**THE DETERMINATION OF MINIMUM FLOWS FOR SULPHUR
SPRINGS, TAMPA, FLORIDA**

SCIENTIFIC REVIEW PANEL

Scientific Review Panel Report

Sulphur Springs Macrofauna

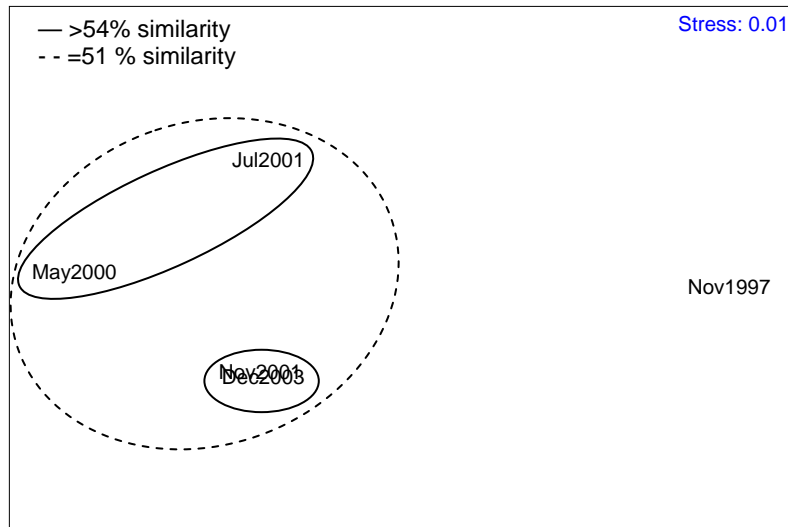
The discussion of macrofaunal changes in the text (Section 3.7.3) is based on simply comparing highlighted species. A statistical analysis is preferred, and the MDS approach provides a less subjective and more robust analysis. When this analysis is performed, the 1997 community structure (after a prolonged drought and period of withdrawal) was different from the other four sampling times, and shares only 38% similarity with samples collected after May 2000. However, November 2001 and December 2003 (occurring during high flow) are very similar (57%), and the May 2000 and the July 2001 samples (occurring during low flow) were also very similar (54%). All four of these sampling dates shared 51% of species in common. This discussion above is similar to that presented in the text (pages 3-21 through 3-22), but it adds some statistical certainty.
